SAFETY RECALL

TITLE: Addition of a lift door telltale

PRODUCT: MBII MPV 2010 et 2011

Reference : 11-043-LDU

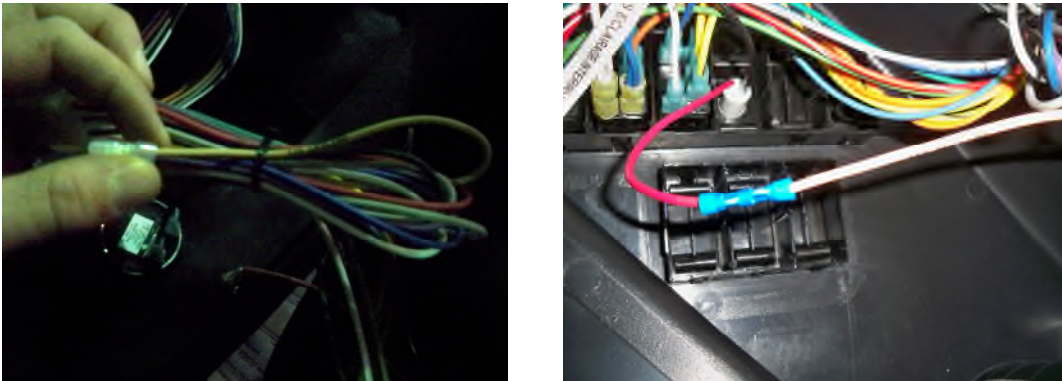
- 1- Remove 3 screws holding the top switch console to access wires.
- 2- Remove the plastic cover plate and install the new cap holding the light.

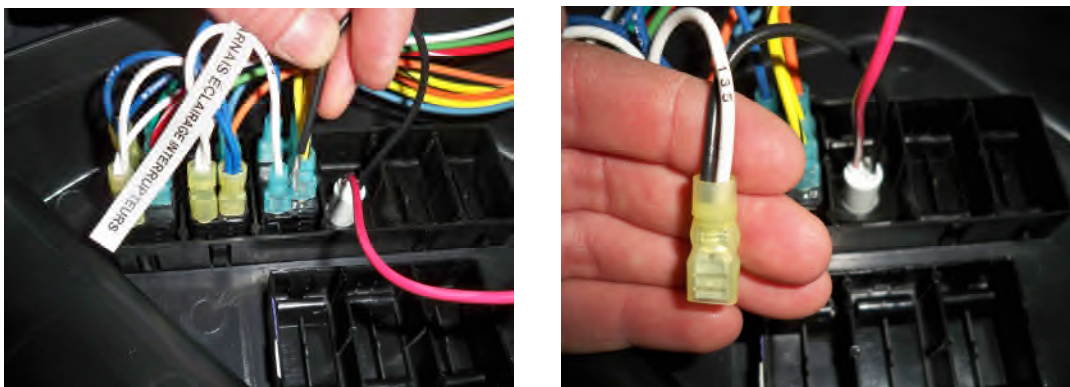
- 3- Locate the unused tan wire # 124 under the console, cut off the closed end connector and use a blue terminal junction to connect it to the light's red wire.

- 4- Connect the alarm's black wire with the white wire of the closest switch with the yellow female connector and reinsert in switch tab.
